SUFFOLK DOWNS REDEVELOPMENT

Supplemental Information Document

MAY 1, 2019

SUBMITTED TO
Boston Planning &
Development Agency

Figure 2.11a
District-Wide Flood Resilience Strategy 1

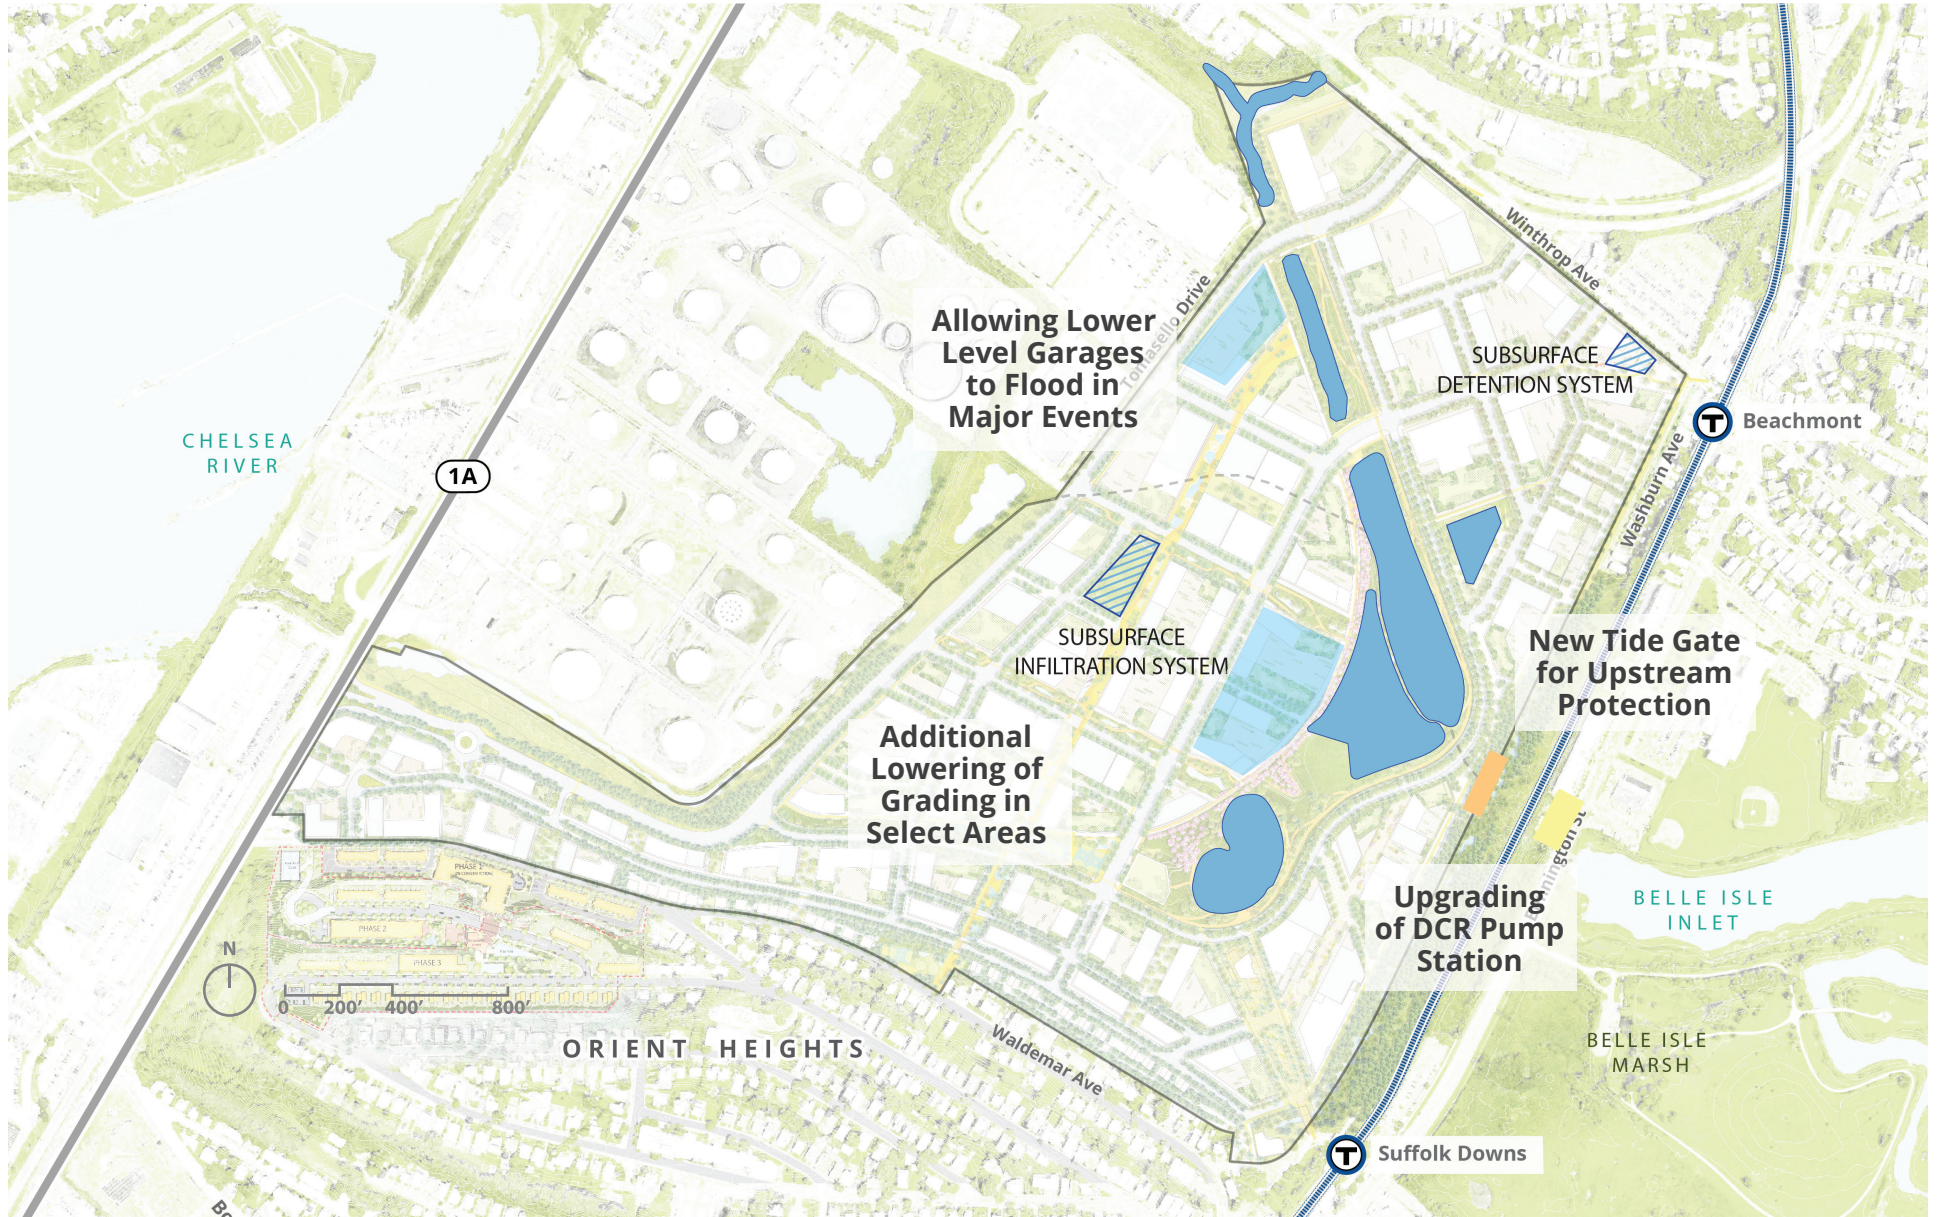
Imagine Boston 2030 specifies that new open spaces will be designed to meet the needs of residents and workers, and that new development will create spaces for arts and culture. As outlined in previous comments, the development will support residents and workers. Additionally, it will provide ample civic spaces to support community, culture and the arts. This includes civic plazas like Beachmont and Belle Isle Square as well as a Civic Node and pavilion within the Central Common. As shown in Figure 2.11a and 2.11b, the plan is also in line with Boston 2030's goals of

Figure 2.15
Canopy Strategy Overall

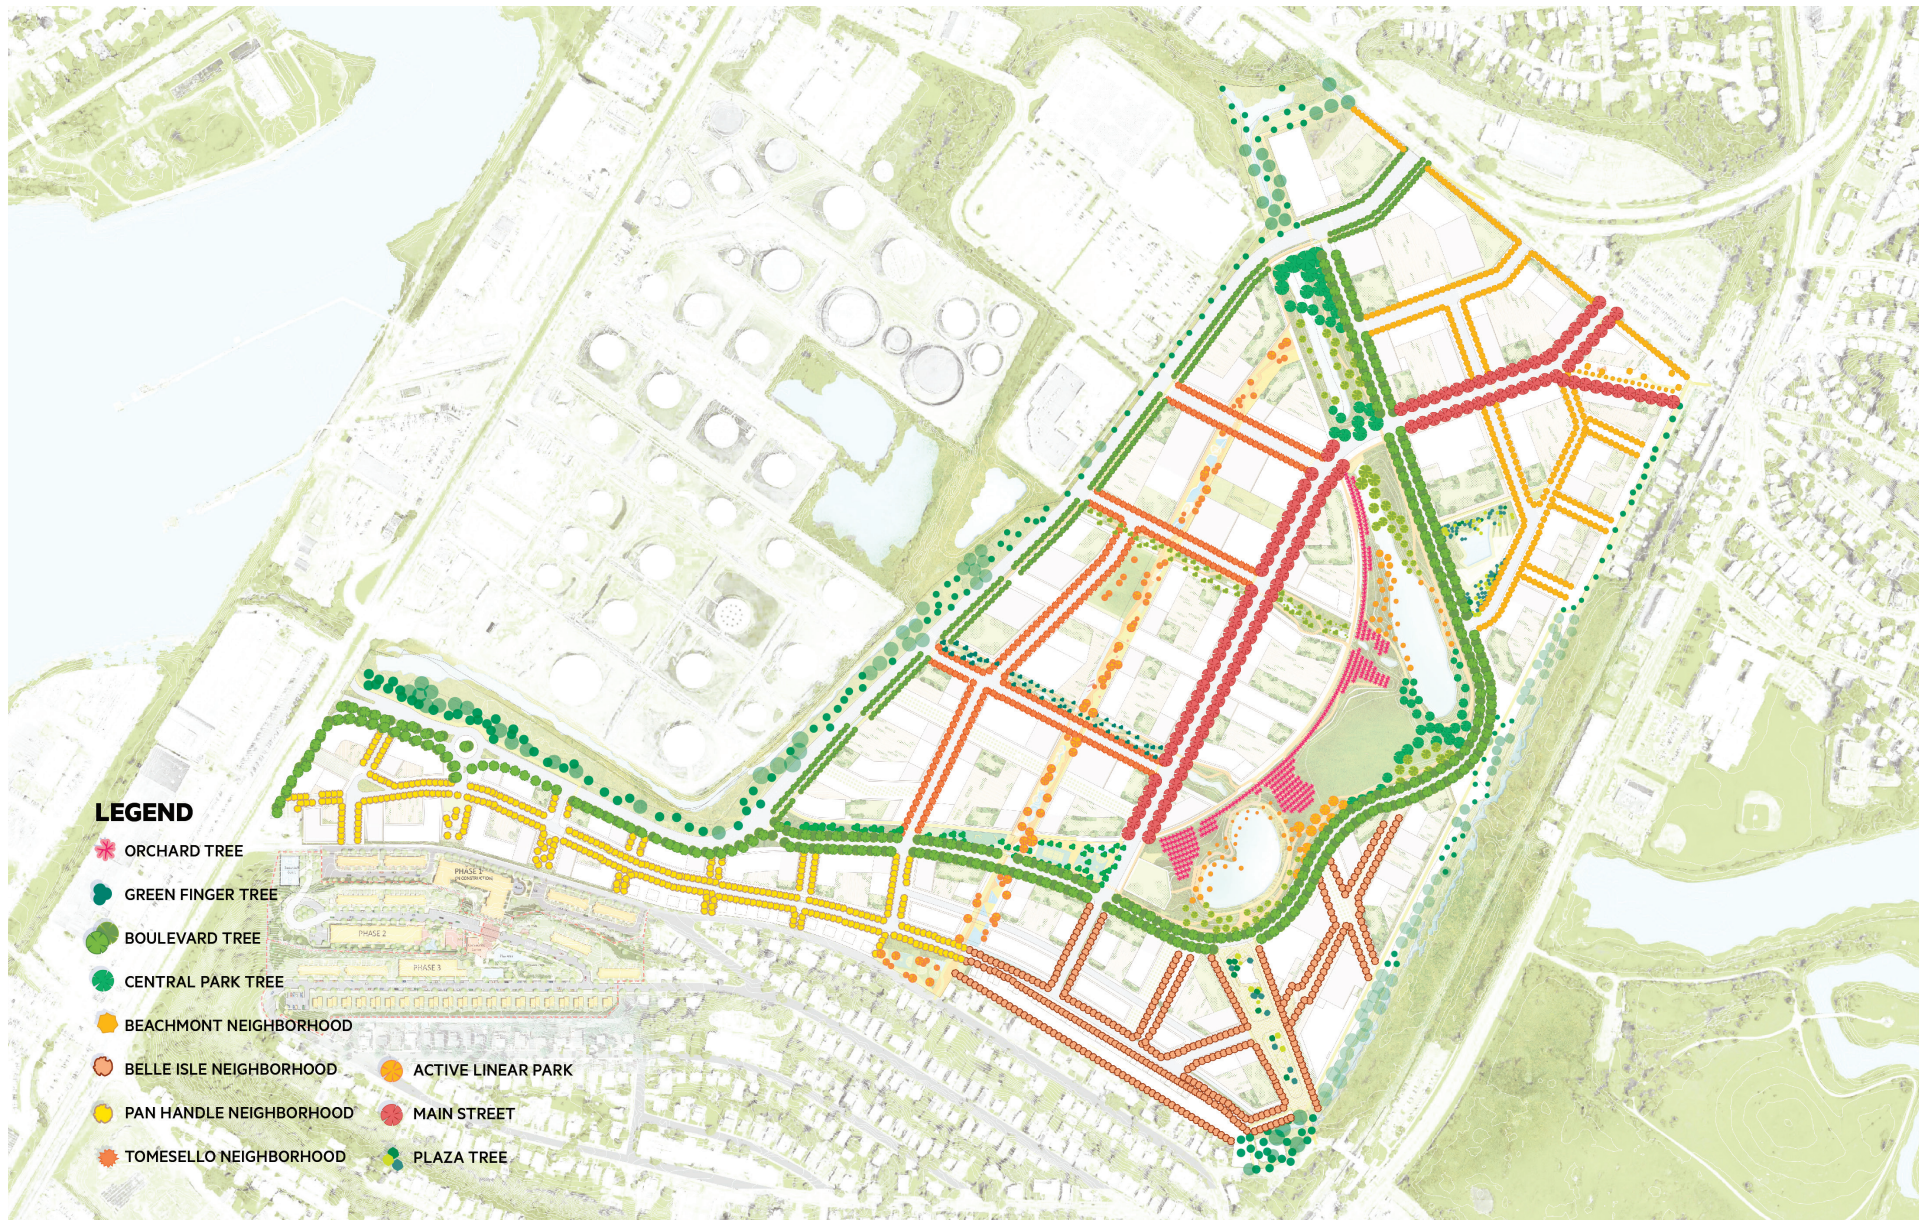
The open space design will continue to plan for climate change. In addition to planning for water and shade elements, the Proponent is considering other elements like tree planting as a key measure to reducing climate impact. Refer to Figure 17. To reduce urban heat island effect, the Project team is utilizing tree planting, maximizing vegetated surfaces, and specifying high albedo surfaces. Tree species will be carefully selected to include coastally adapted and salt tolerant species, drought tolerant and water tolerant species, and species resistant to pest damage.
